Submission on behalf of Port Phillip City Council

Planning Permit Application PA2604230 – 60-74 Park Street, South Melbourne

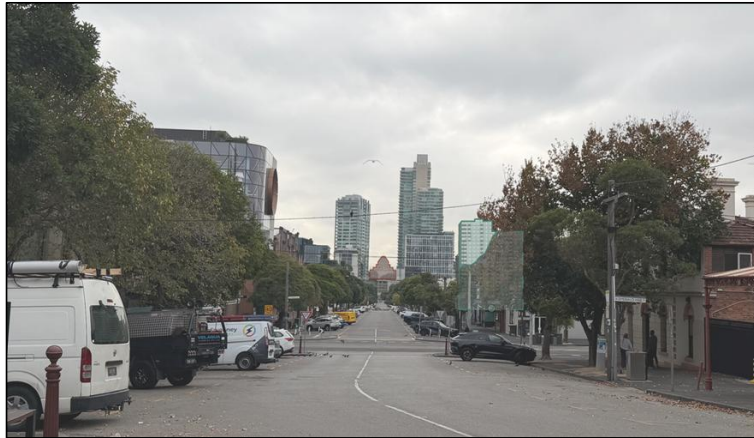
21. The scale of the proposal represents a substantial departure from its immediate context. The 19-storey frontage exceeds the height of 52-58 Park Street by three storeys (approximately 11 metres) and 88 Park Street by seven storeys (approximately 25.1 metres). A further three storeys are located at the rear of the site, increasing the overall height to 22 storeys. This additional height is not expressed through discernible stepping, tapering, or recession, and instead contributes to a continuous and expansive building form, particularly when viewed from key longer-range vantage points.
